E3649A-04C**S E R V I C E N O T E**Supersedes:
E3649A-04B**E3649A DC Power Supply****Serial Numbers: MY51240078 to MY53190006****Metal Strap Kit for tightening loose bumper and for fitting rear lock link in side-by-side rack mounting****Parts Required:**

July 9, 2013

Figure 1: Top view 3mm gap observed between two different chassis designs

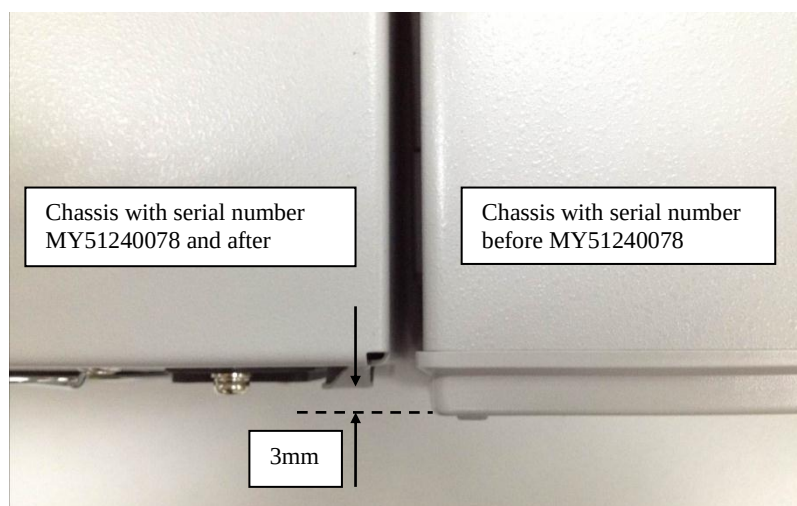
Situation 2:

The chassis depth difference between the two designs is 3mm as shown in Table 1 and Figure 1 below.

Figure 2: Top view 3mm gap observed on rear lock link for side-by-side rack mounting

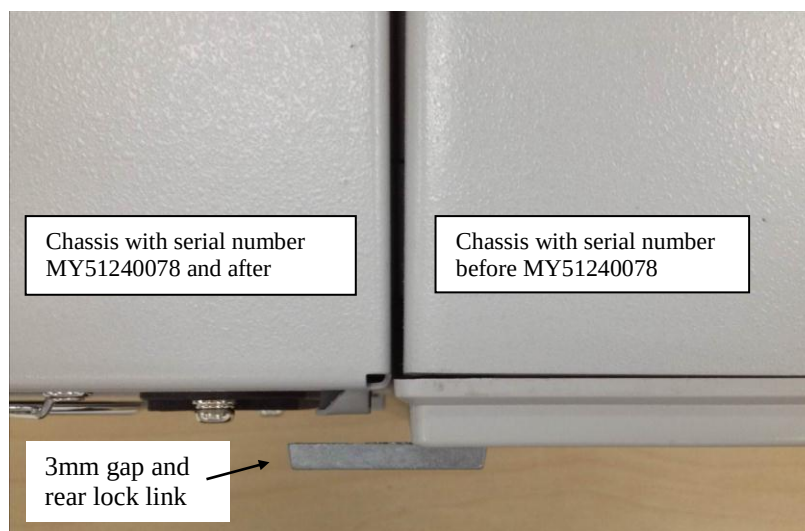
The 3 mm gap between the two different chassis may cause difficulties in securing them together using a rear lock link kit (part number 0050-2167) for side-by-side rack mounting as shown in Figure 2 below.

Solution for Situation 2

Use metal strap (part number E3631-07901), and stack the provided two metal straps together to form 3mm thickness and secure it with the provided screws on the rear lock link as shown in Figure 4 below.
